SUNDRY NOTICES AND REPORTS ON WELLS (DO NOT USE THIS FORM FOR PROPOSALS TO DRILL OR TO DEEPEN OR PLUG BACK TO A DIFFERENT RESERVOIR. USE "APPLICATION FOR PERMIT" (FORM C-101) FOR SUCH PROPOSALS.)		WELL API NO.
1. Type of Well: Oil Well ☐ Gas Well ☐ Other ☐		5. Indicate Type of Lease STATE ☐ FEE ☐
2. Name of Operator		6. State Oil & Gas Lease No.
3. Address of Operator		7. Lease Name or Unit Agreement Name
4. Well Location Unit Letter _____: _____ feet from the _____ line and _____ feet from the _____ line Section _____ Township _____ Range _____ NMPM _____ County _____		8. Well Number
11. Elevation (Show whether DR, RKB, RT, GR, etc.)		9. OGRID Number
		10. Pool name or Wildcat

1 API Number 30-015-50007		2 Pool Code 98220		3 Pool Name Purple Sage; Wolfcamp (Gas)	
4 Property Code 329348		5 Property Name POTATO BABY STATE COM			6 Well Number 906H
7 OGRID No. 229137		8 Operator Name COG OPERATING LLC			9 Elevation 3072.49'

POTATO BABY STATE COM #906H

Operator: COG OPERATING LLC 600 W Illinois Ave Midland, TX 79701	OGRID: 229137
	Action Number: 181975
	Action Type: [C-103] NOI Change of Plans (C-103A)

Potato Baby State Com 906H

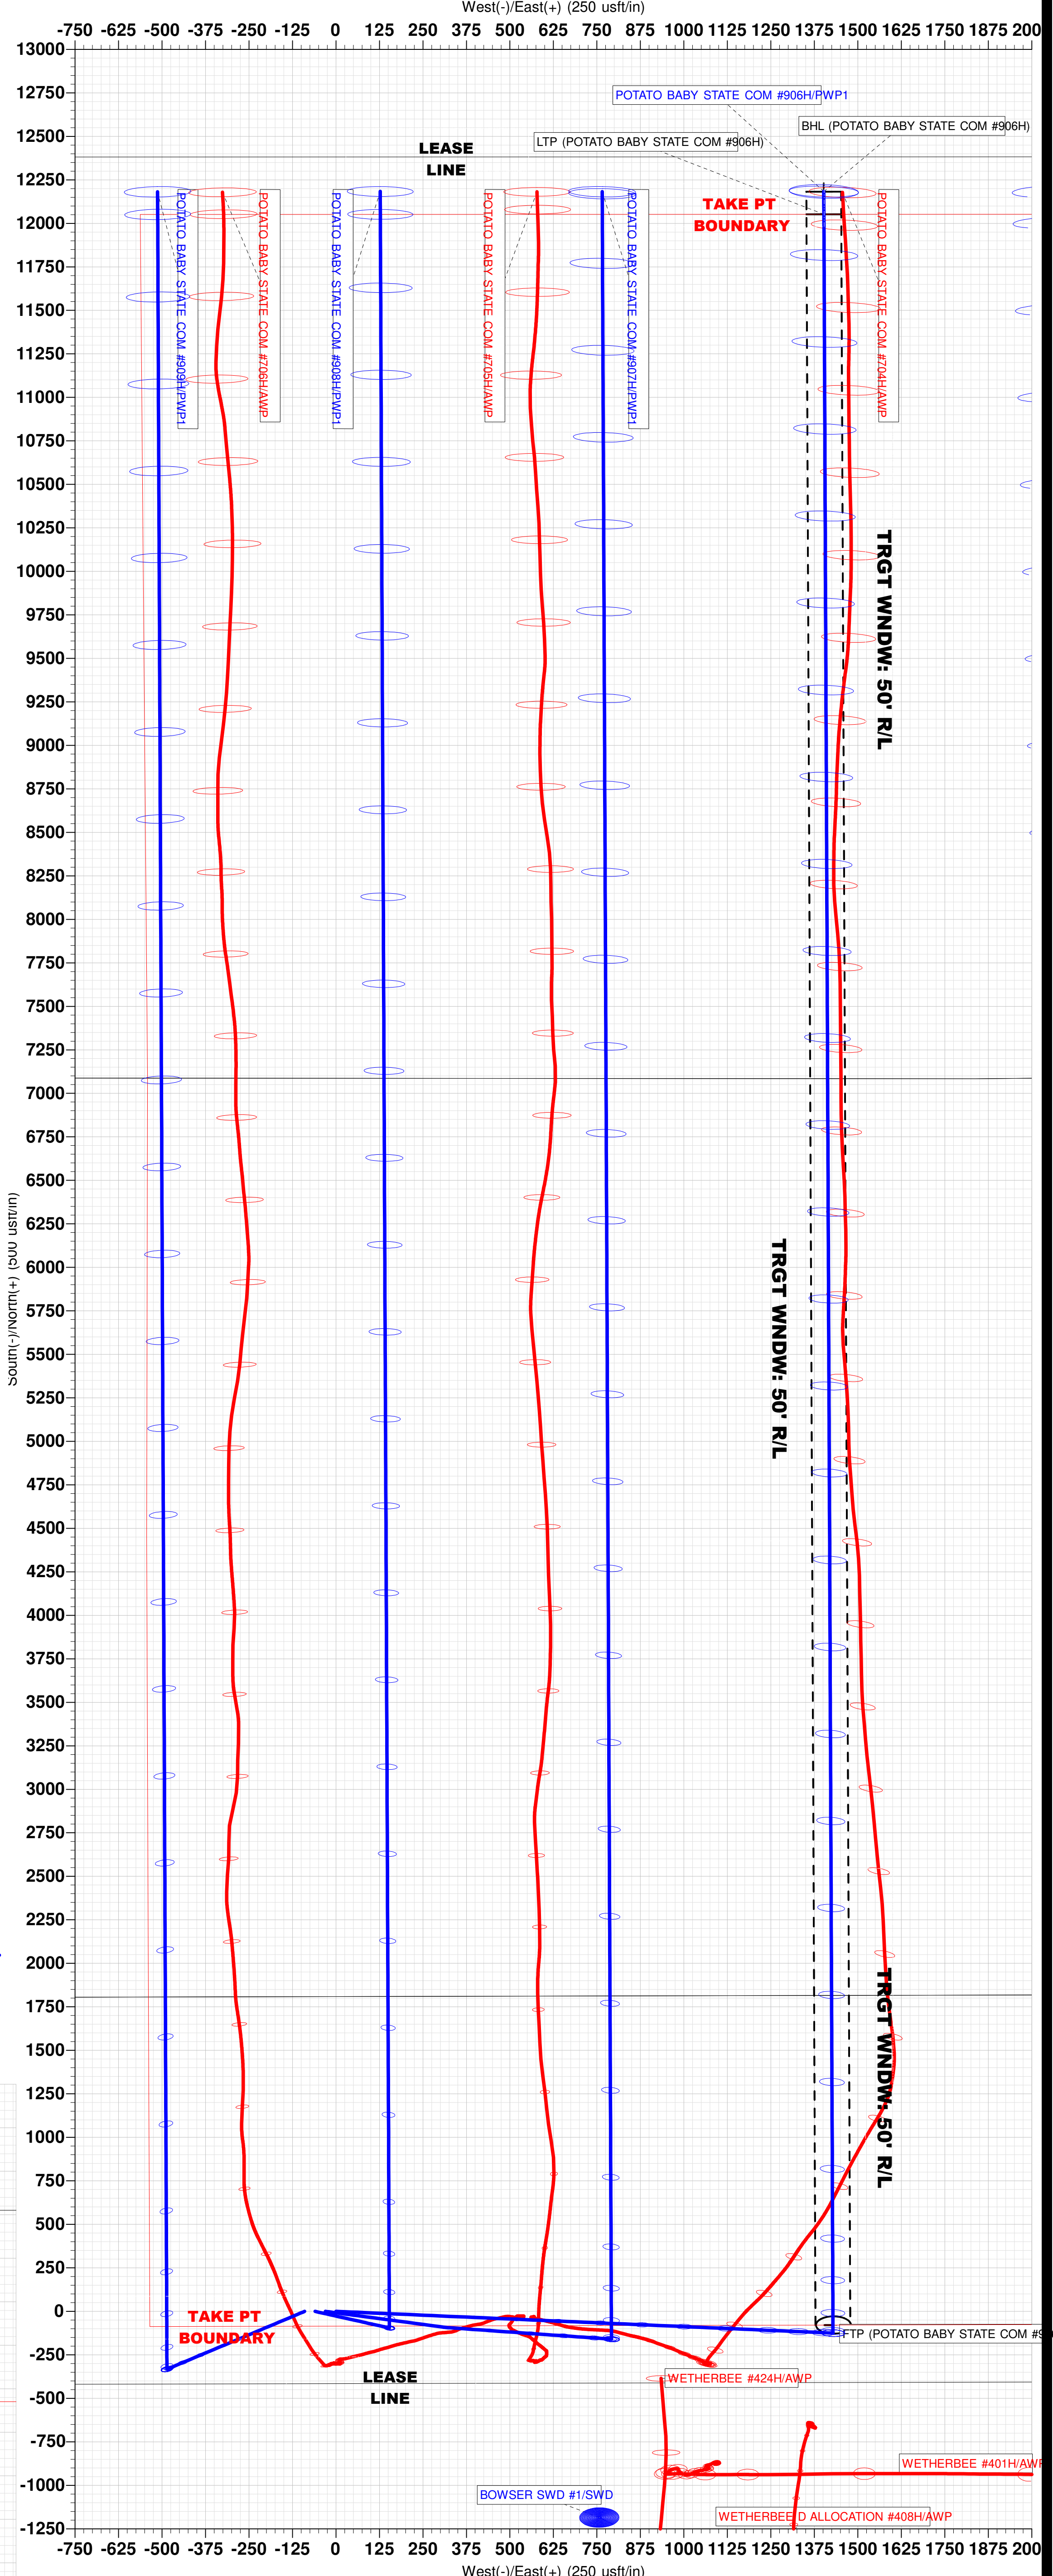
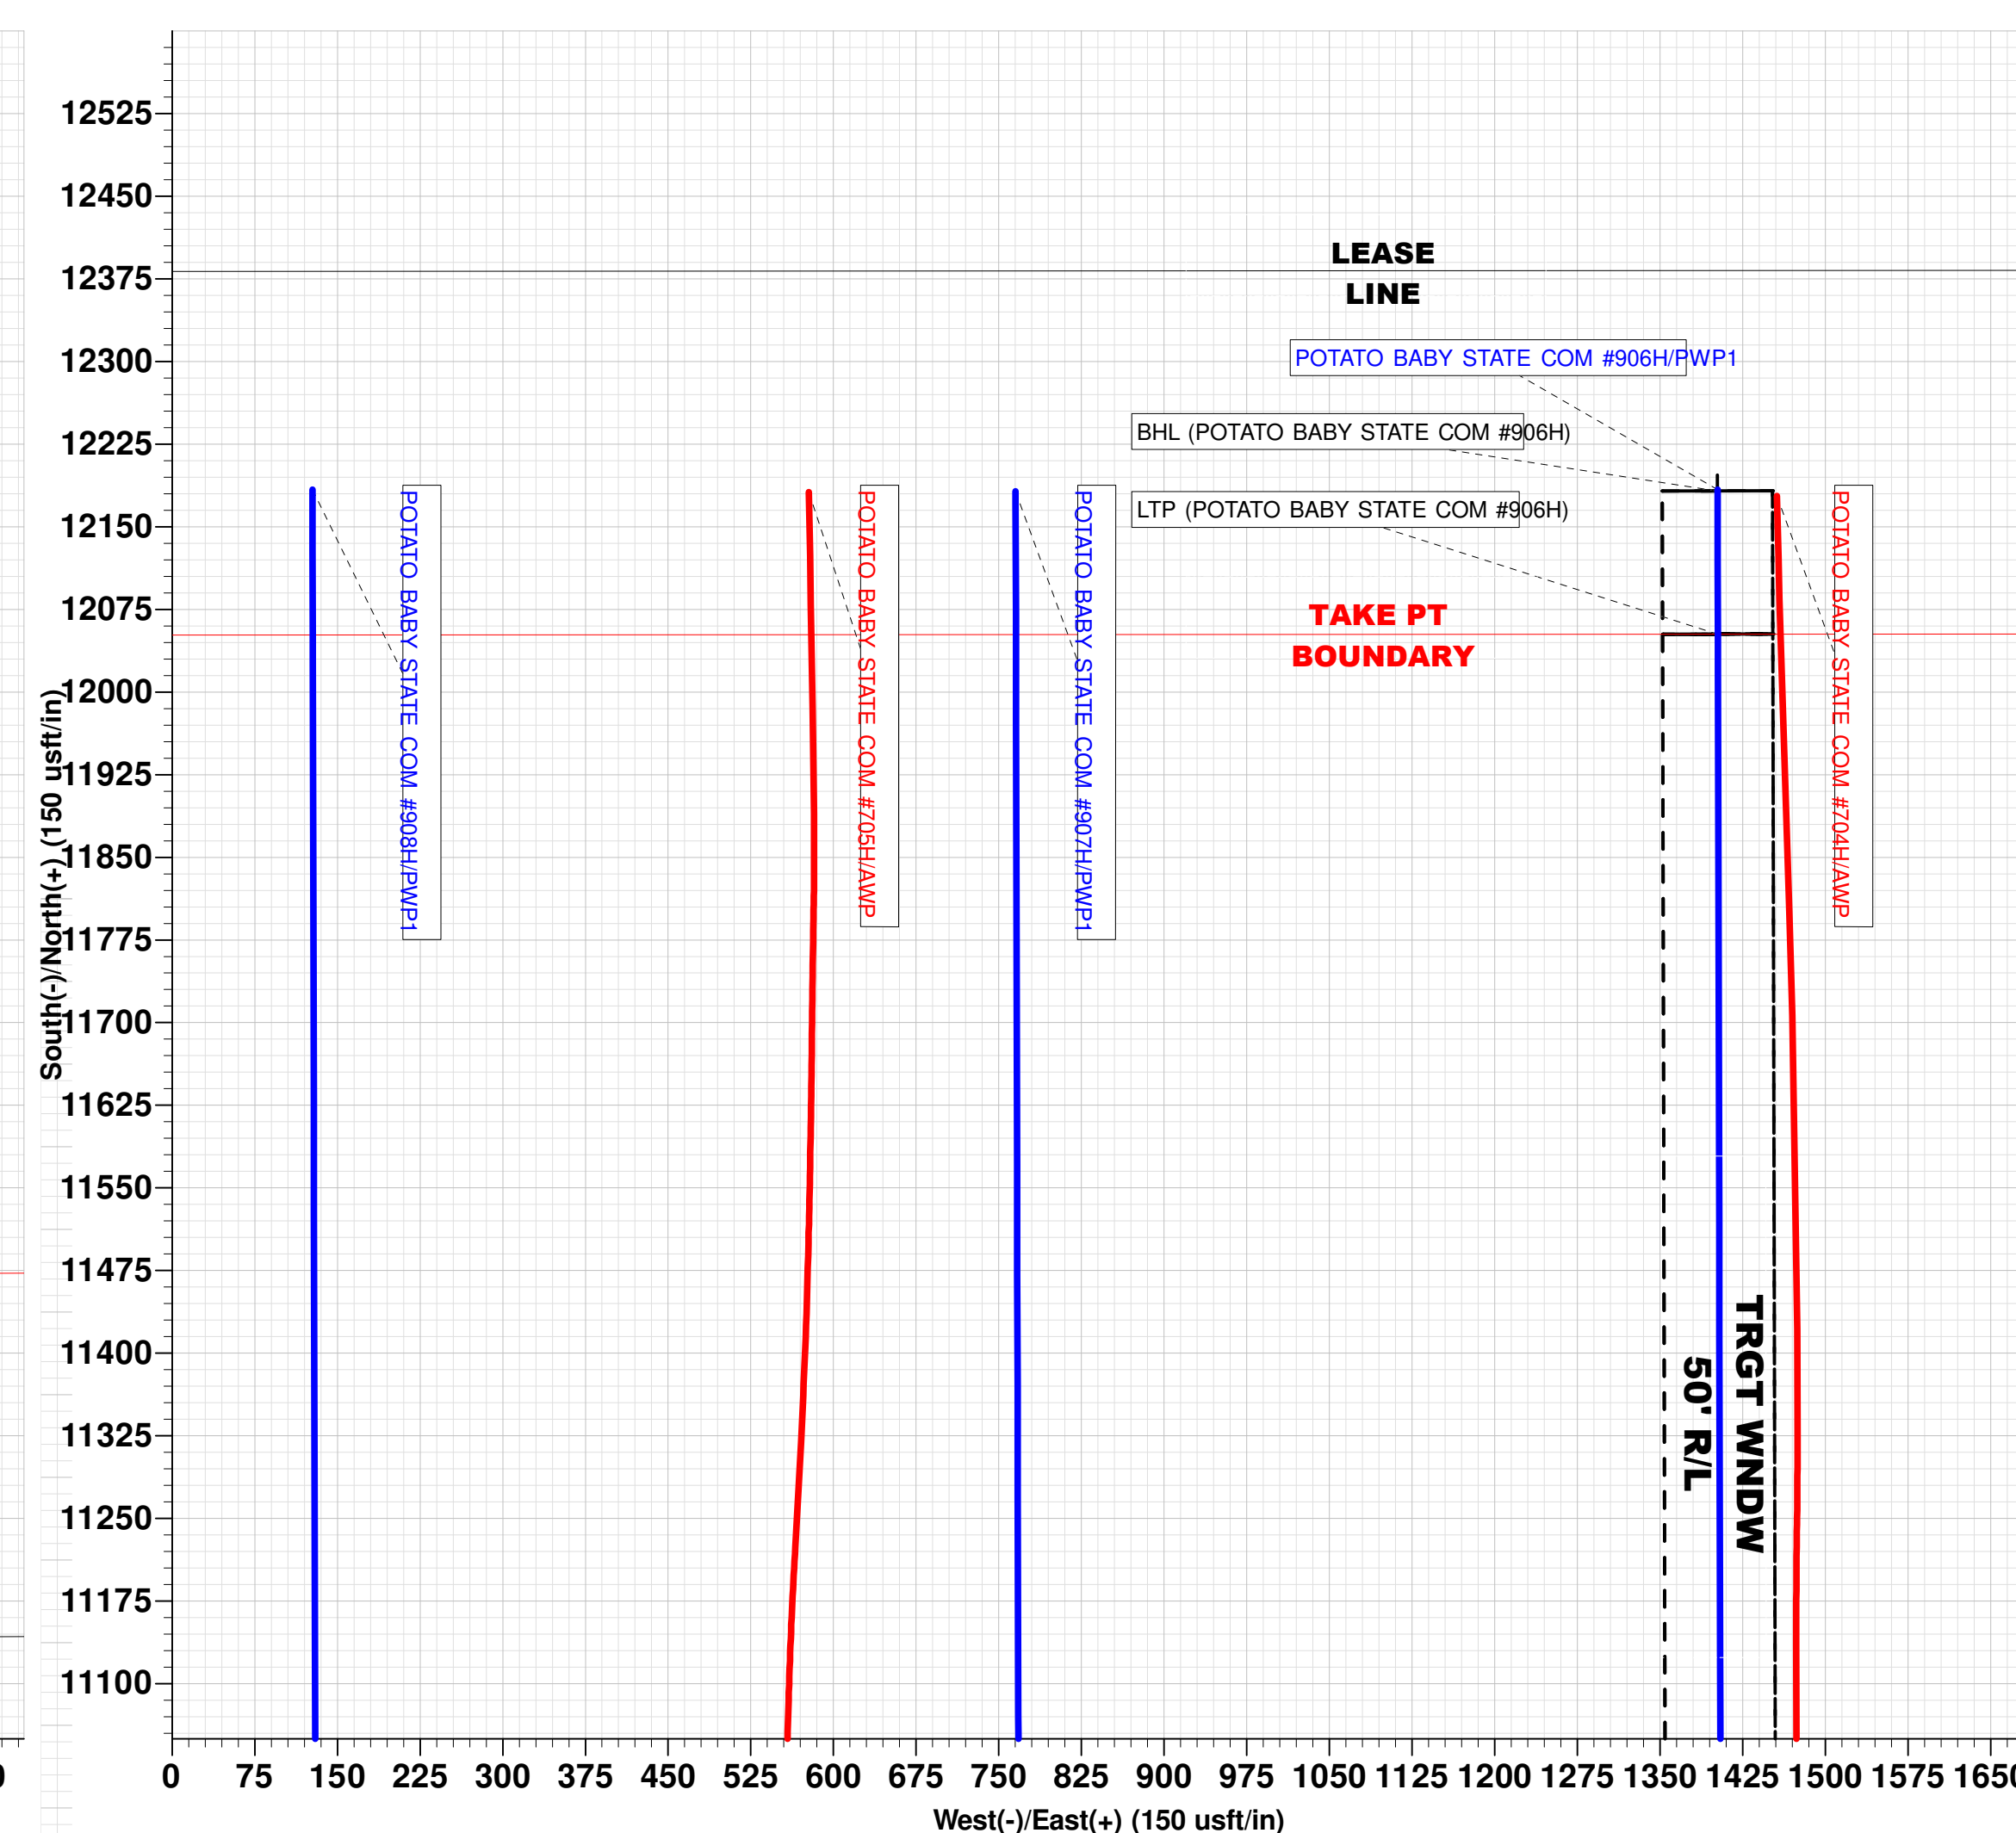
NOTICE OF INTENTION TO:		SUBSEQUENT REPORT OF:	
PERFORM REMEDIAL WORK ☐	PLUG AND ABANDON ☐	REMEDIAL WORK ☐	ALTERING CASING ☐
TEMPORARILY ABANDON ☐	CHANGE PLANS ☐	COMMENCE DRILLING OPNS. ☐	P AND A ☐
PULL OR ALTER CASING ☐	MULTIPLE COMPL ☐	CASING/CEMENT JOB ☐	
DOWNHOLE COMMINGLE ☐			
CLOSED-LOOP SYSTEM ☐			
OTHER: ☐	Change BHL ☒	OTHER: ☐

UL or lot no.	Section	Township	Range	Lot Idn	Feet from the	North/South line	Feet from the	East/West line	County
C	22	26-S	28-E		200'	NORTH	2245'	WEST	EDDY
